July 31, 2018

Ref: 12815.00

Re: DEP File No. SE 049-0805
Revised Notice of Intent: South Coast Rail – New Bedford Main Line NOI
New Bedford, Massachusetts
Responses to Nitsch Engineering, Inc. Comments of July 16, 2018

Lined Bioretention Basin W/ Underdrain

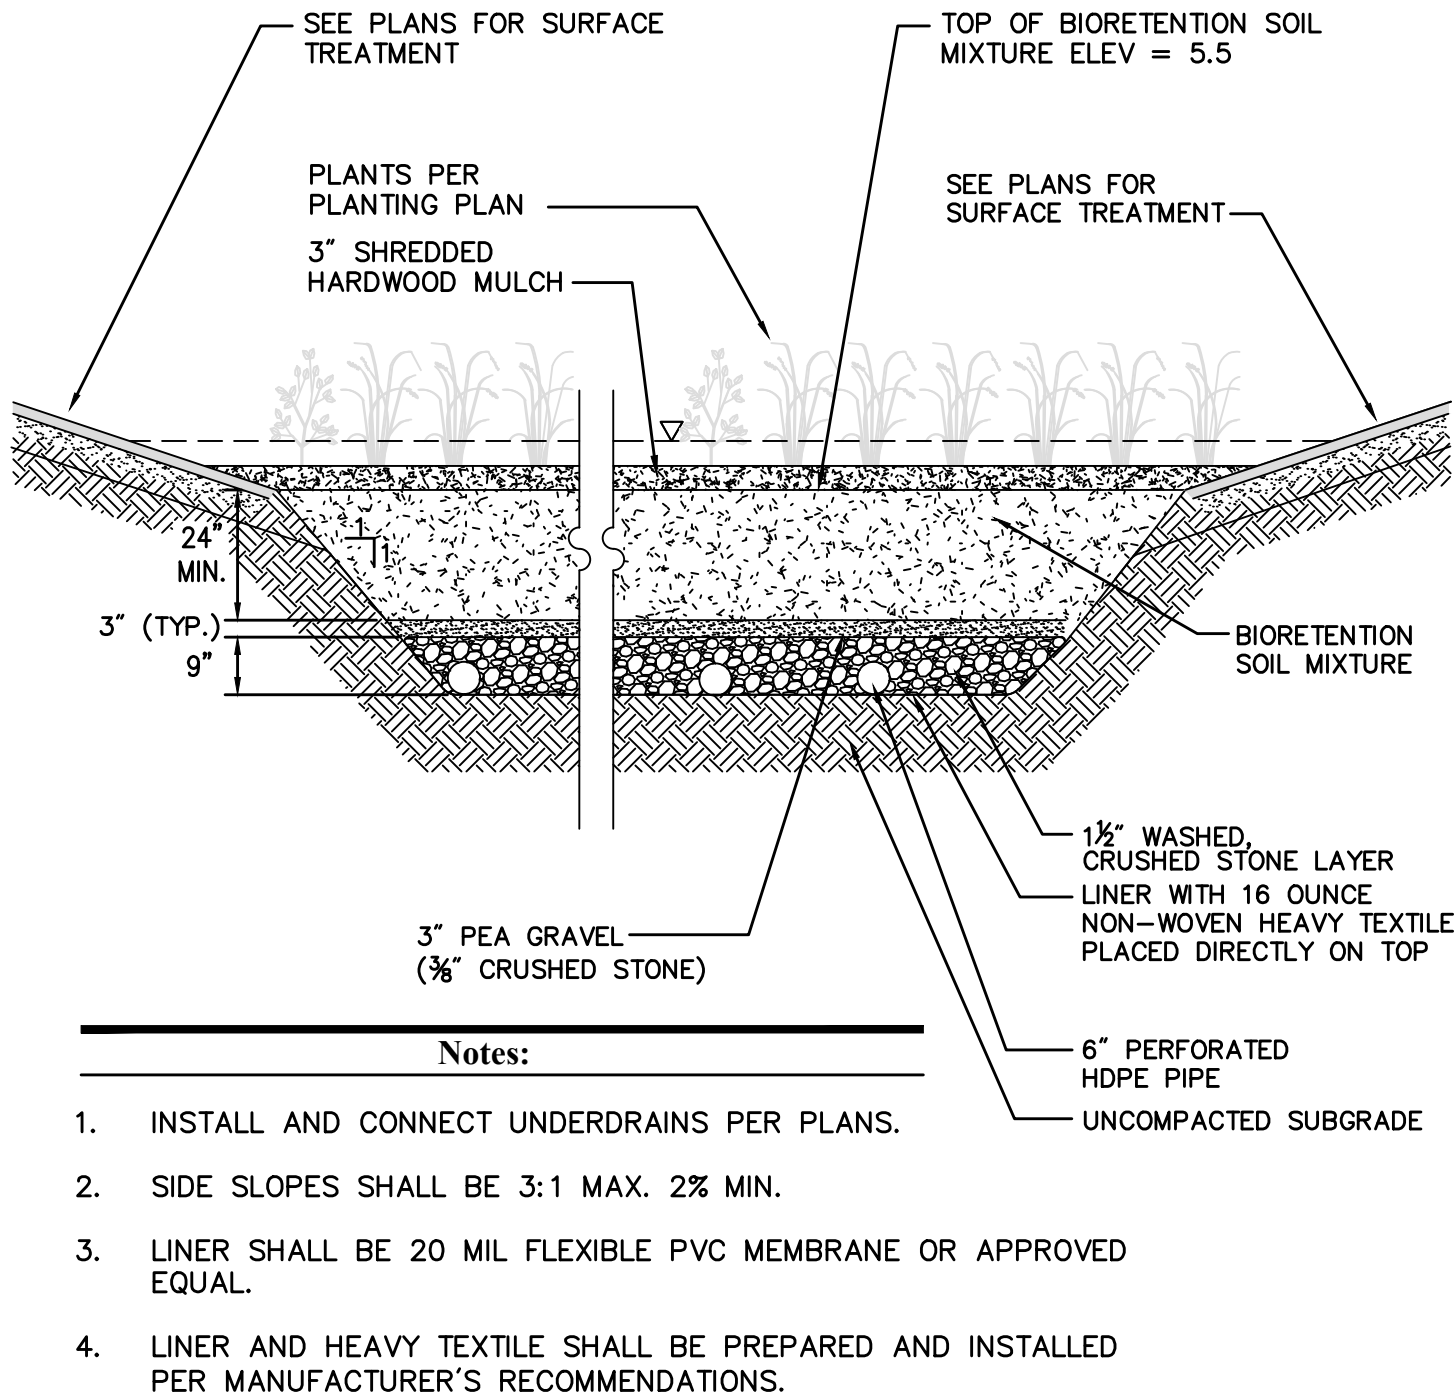
Comment #1: *Bioretention basin 1 provides 9 inches of freeboard for the 100-year storms. The Guidelines require a foot of freeboard in bioretention basins.*

Response #1: Attached is the Bioretention section from the MADEP Stormwater Handbook Vol. 2 Ch. 2. We have highlighted the paragraph that describes the need for 3" of freeboard when adjacent to a parking area. This document was hand delivered to the Commission at the 7/17/18 public hearing.

Pretreatment Filter Strip

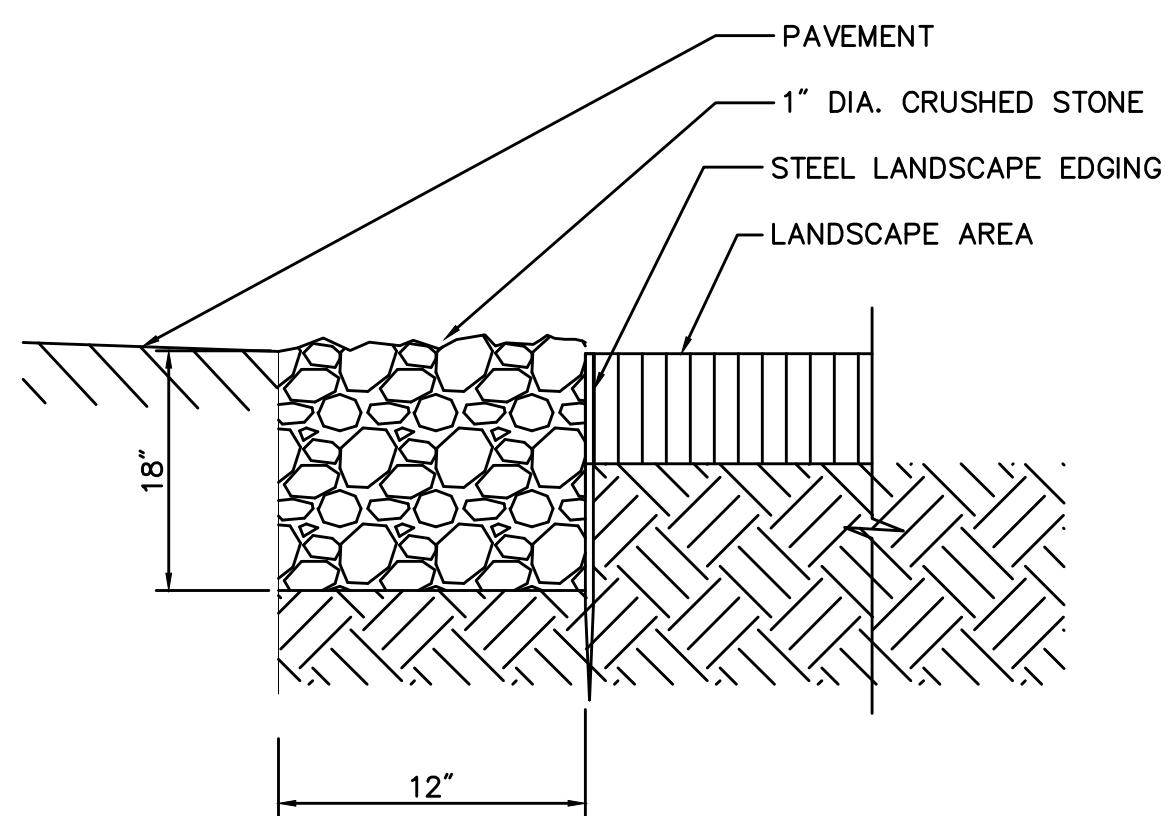
Comment #12: *The Applicant has indicated the sheet CV-311 has been revised to remove the Stone Diaphragm detail and that this sheet has been resubmitted. Sheet CV-311 was not resubmitted with the last submittal. The Stone Diaphragm Detail remains on Sheet CV-312.*

Response #12: The Stone Diaphragm detail title has been revised to Pretreatment Filter Strip to match the call out references on Sheets GD-300 and 301, which provide the location and layout of this feature. The detail is only included on Sheet CV-312 (attached).
